3-1 – 12

301.3 (New)

Proposed Change as Submitted

Committee Action

Figure 4 - Turning diameter (examples for various wheelchair types)

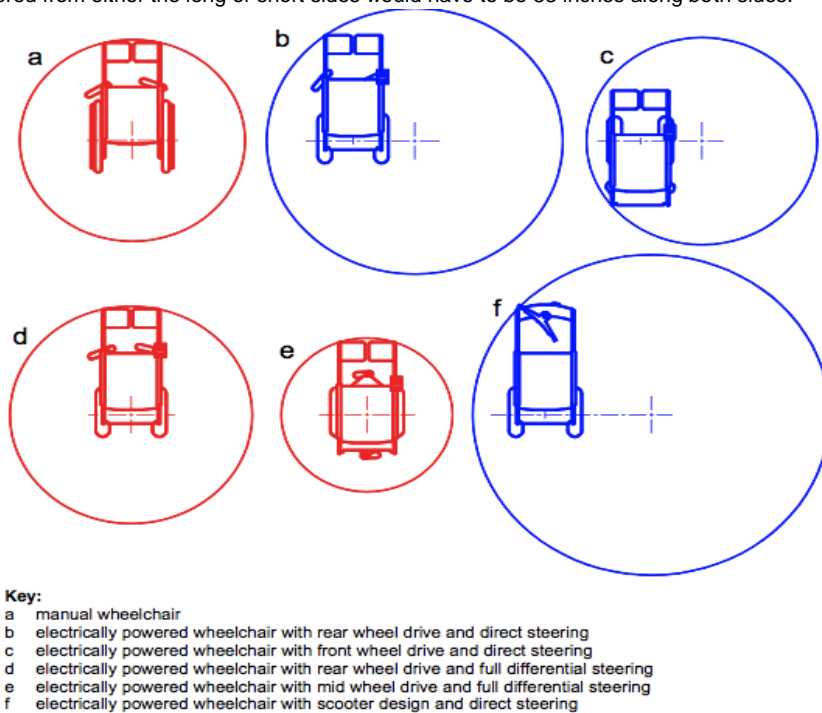
This observation raises the question – should the built environment be changed to accommodate poorly designed wmds or ought those choosing poorly designed wmds be informed that their vehicle may not be well accommodated? The analogy is the parking lot at the grocery store. If you choose to drive a stretch limo, RV, bus, or other vehicle that is bigger than a typical parking space you are welcome to shop, but don't expect a parking space near the entry. Ultimately this is a political and not a technical question.

Committee Reason: The WMTG was able to bring forth 2 key proposals as a result of its review of the studies of persons using wheeled mobility devices. This is one of the proposals; the other found in 3-13-12 addresses the clear floor space. Many Committee members were unsure of approving either change without knowing the implications in the balance of the Standard. The WMTG a working decision on this proposal and 3-13-12 before considering the balance of the Standard and where additional correlating changes would be needed. Those changes developed between the August and January meetings are reflected in proposals 3-6A-12 through 3-6F-12 and 3-13A-12 through 3-13K-12.

Figure 304.3(a)
SIZE OF TURNING SPACE

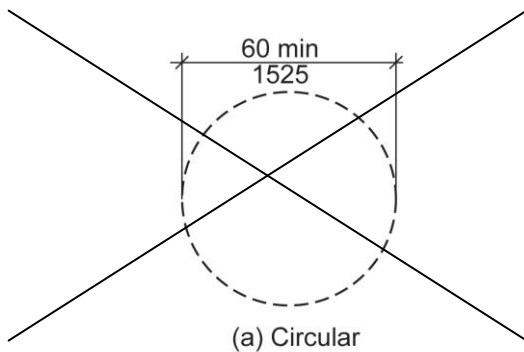
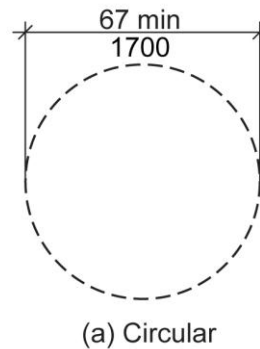
304.3.1 Circular Space. The turning space shall be a circular space with a ~~60-inch~~ 67-inch (~~1525~~ 1700 mm) minimum diameter. The turning space shall be permitted to include ~~knee and~~ toe clearance complying with Section 306.3.

Reason: Many of the technical requirements of the ICC/ANSI A117.1 (2009) Accessible and Usable Buildings and Facilities (ICC/ANSI) designed to accommodate wheeled mobility users are based on research completed from 1974 to 1978 using a research sample that included about 60 individuals who used manual wheelchairs (Steinfeld et al., 1979).

Proposal 3-9

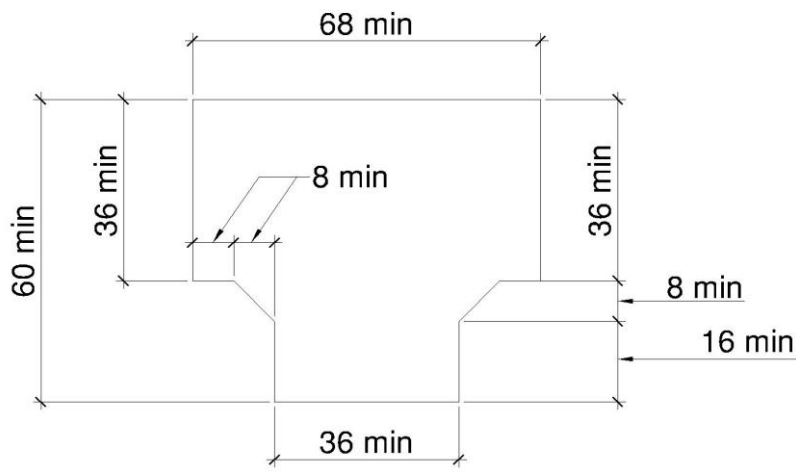
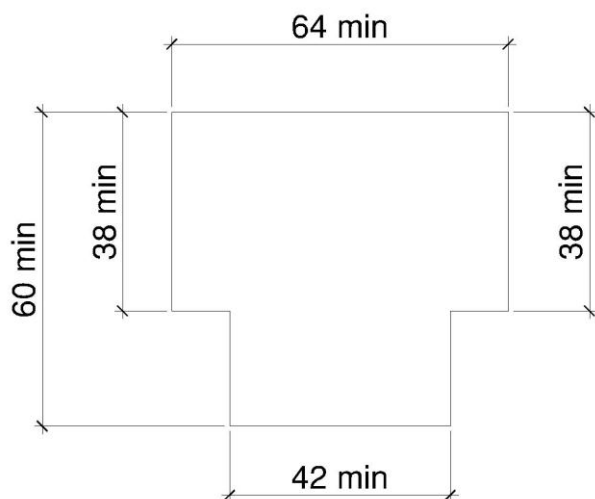
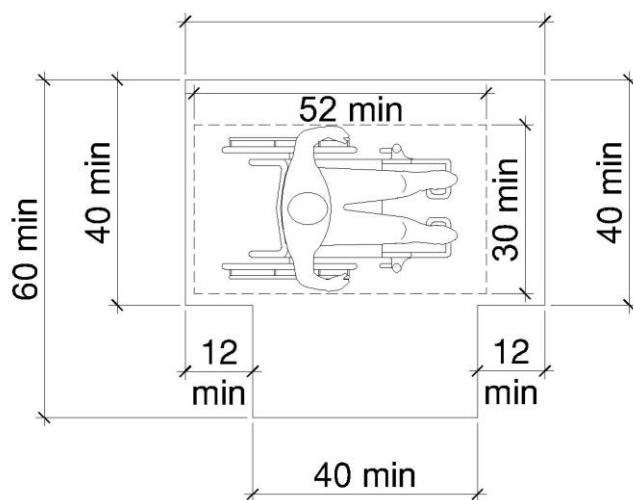
Modification Text not prepared. Need the text to reflect the 3 diagrams

Committee Reason: The Committee explored the various options and limitations for regarding making the T-shaped turn. While the dimensions shown in the figure labeled Proposal 3-9 were the base of the discussions, the Committee concluded that the 3 designs should be shown in the text (perhaps in a table) as 3 equal options for design the space. The Committee approved the figures; asked staff to develop text.

FIG. 304.3
SIZE OF TURNING SPACE

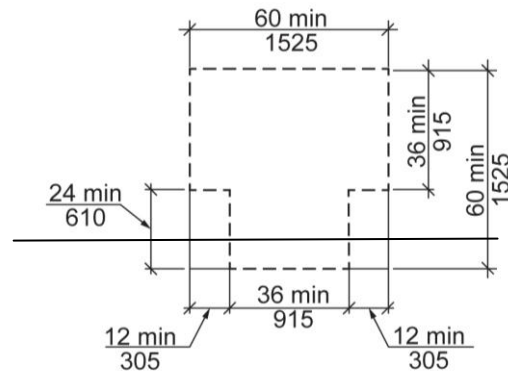
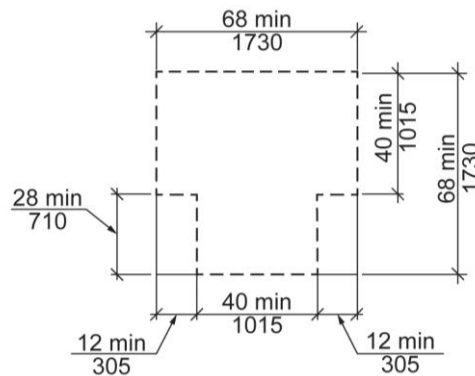
304.3.2 T-Shaped Space. The turning space shall be a T-shaped space within a ~~60-inch~~ 68-inch (1525 ~~1725~~ mm) minimum square, with arms and base ~~36~~ 40 inches (915 ~~1015~~ mm) minimum in width. Each arm of the T shall be clear of obstructions ~~12~~ 14 inches (305 ~~355~~ mm) minimum in each direction, and the base shall be clear of obstructions ~~24~~ 28 inches (610 ~~710~~ mm) minimum. The turning space shall be permitted to include knee and toe clearance complying with Section 306 only at the end of either the base or one arm.

2. Where the arms of the T-shaped space are 44 inches (1115 mm) minimum in width, the base of the T shall be permitted to be 36 inches (915 mm) minimum in width, with the arms of the T clear of obstructions 16 inches (405 mm) minimum in each direction.

305.7.2, Figure 305.7(a)

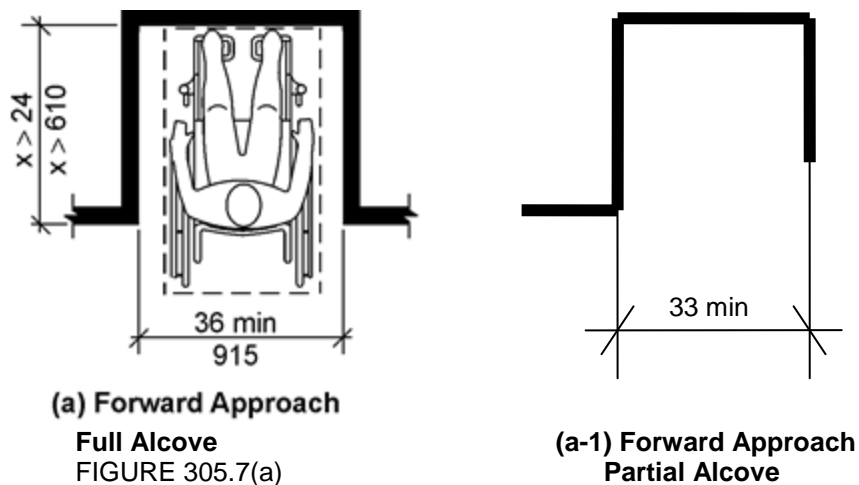
Revise figure to change width from 36 to 30 inches.

FIG. 306.2
TOE CLEARANCE

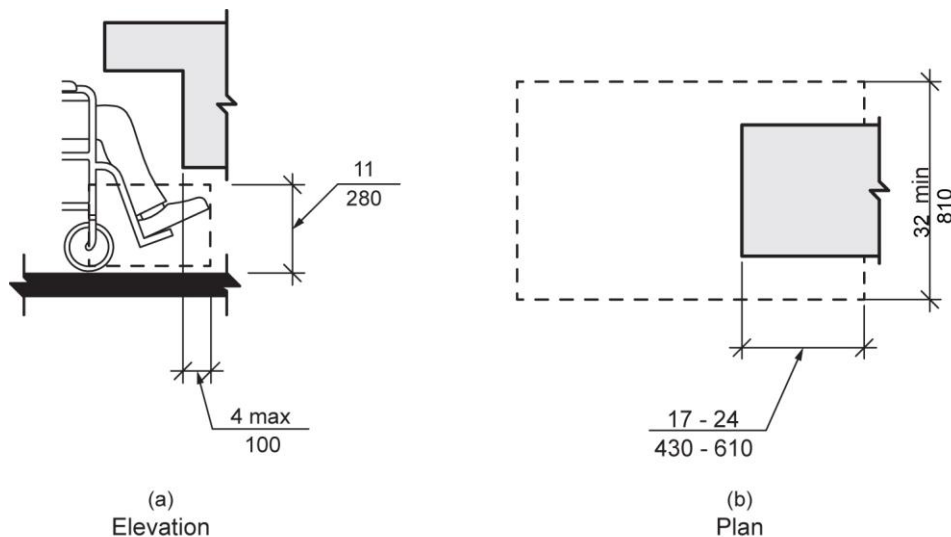
306.2.1 General. Space beneath an element between the floor and ~~9~~ 11 inches (~~230~~ 280 mm) above the floor shall be considered toe clearance and shall comply with Section 306.2.

306.2.2 Maximum Depth. Toe clearance shall be permitted to extend ~~25~~ 24 inches (~~635~~ 610 mm) maximum under an element.

306.2.5 Width. Toe clearance shall be ~~30~~ 32 inches (~~760~~ 810 mm) minimum in width.

NOTE: This change necessitates a change to Fig. 306.2 and Fig. 306.3 to ensure consistency. Thus, the proposed revised figures have been attached, along with the existing figures for comparison purposes.

Committee Reason: Changing the dimensions of these clearance has significant impacts on many features. While the heights of counters, sinks or fountains are not addressed specifically, the proposal would make fountain designs, work surfaces, sinks and similar features difficult to provide if heights are not raised. There were many concerns that this increase in clearances would force increase height for these features; many of the Committee objected to the potential for these other elements to be affected.

FIG. 306.3
KNEE CLEARANCE

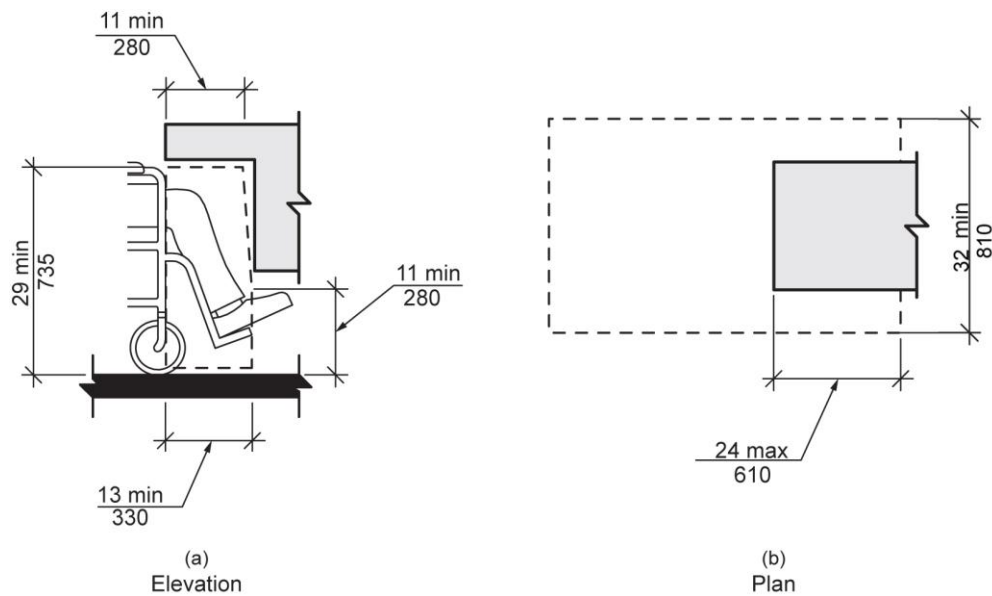
306.3.1 General. Space beneath an element between ~~9~~ 11 inches (~~230~~ 280 mm) and ~~27~~ 29 inches (~~685~~ 735 mm) above the floor shall be considered knee clearance and shall comply with Section 306.3.

306.3.2 Maximum Depth. Knee clearance shall be permitted to extend ~~25~~ 24 inches (~~635~~ 610 mm) maximum under an element at ~~9~~ 11 inches (~~230~~ 280 mm) above the floor.

308.2.1, Figure 308.2.1

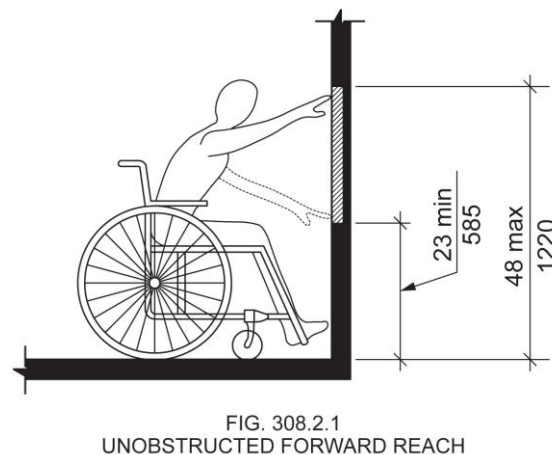
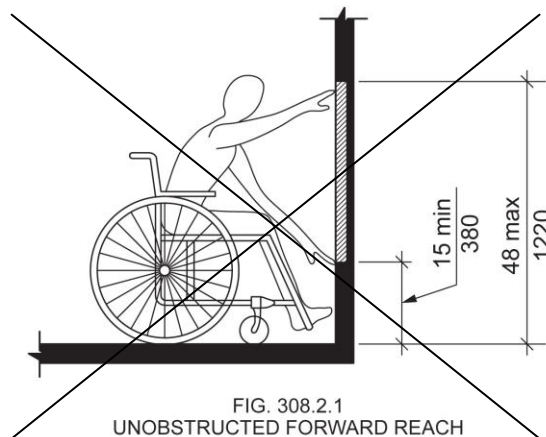
The proposed change would help accommodate a substantial number of manual chair users (51%) and a sub-set of power chair users (36%) that possess reach capability to accomplish a forward unobstructed reach at lower heights. Raising the lower reach limit would undoubtedly also benefit standing individuals and more so individuals that have trouble bending or kneeling (e.g. the elderly). Further, there are no constraints or requirements in building construction that require operable parts (e.g. electrical outlets) to be placed as low as 15 inches but not at 23 inches.

NOTE 2: This change necessitates a revision to Fig. 308.2.1 to ensure consistency. A revised figure is attached.

Committee Reason: In contrast to the side reach proposal which the Committee did not accept, change to forward reach was accepted at the Committee meeting. The case made by the proponent and others is that the forward reach is very restricted, especially when considering the range of mobility devices used. Some members remained concerned that this change would significantly reduce access to electrical outlets, shelving, other equipment and would force redesign of rooms and spaces to accommodate a parallel approach.

FIG. 308.3.1
UNOBSTRUCTED SIDE REACH

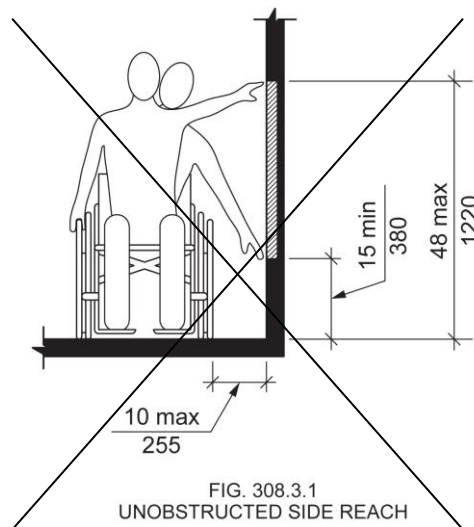
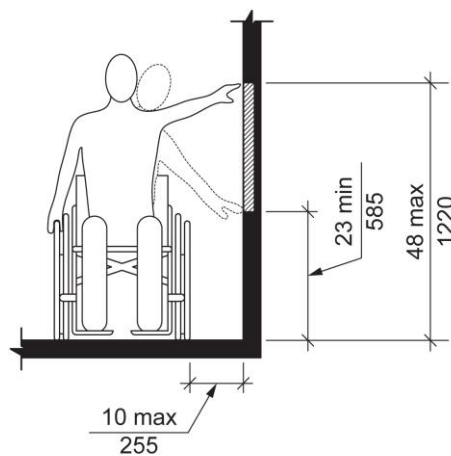
308.3.1 Unobstructed. Where a clear floor space complying with Section 305 allows a parallel approach to an element and the edge of the clear floor space is 10 inches (255 mm) maximum from the element, the high side reach shall be 48 inches (1220 mm) maximum and the low side reach shall be 45 23 inches (~~380~~ 585 mm) minimum above the floor.

The proposed change would help accommodate a substantial number of manual chair users (68%) and power chair users (56%) that possess reach capability to accomplish a forward unobstructed reach at lower heights. Raising the lower reach limit would undoubtedly also benefit standing individuals and more so individuals that have trouble bending or kneeling (e.g. the elderly). Further, there are no constraints or requirements in building construction that require operable parts (e.g. electrical outlets) to be placed as low as 15 inches but not at 23 inches.

NOTE 2: This change necessitates a revision to Fig. 308.3.1 to ensure consistency. A revised figure is attached.

Fig. 308.3.1
Unobstructed Side Reach

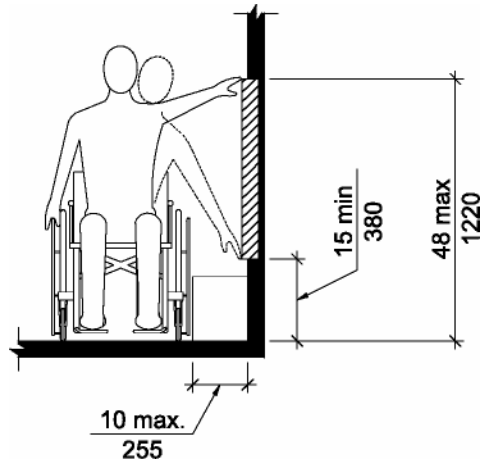
1. Existing elements that are not altered shall be permitted at 54 inches (1370 mm) maximum above the floor.
2. Where an unobstructed side reach is available, thermostats in Type B dwelling and sleeping units shall be permitted at 54 inches.

Reason: Forty eight inches is too low for people not in wheel chairs. This would match UFAS 4.2.6.
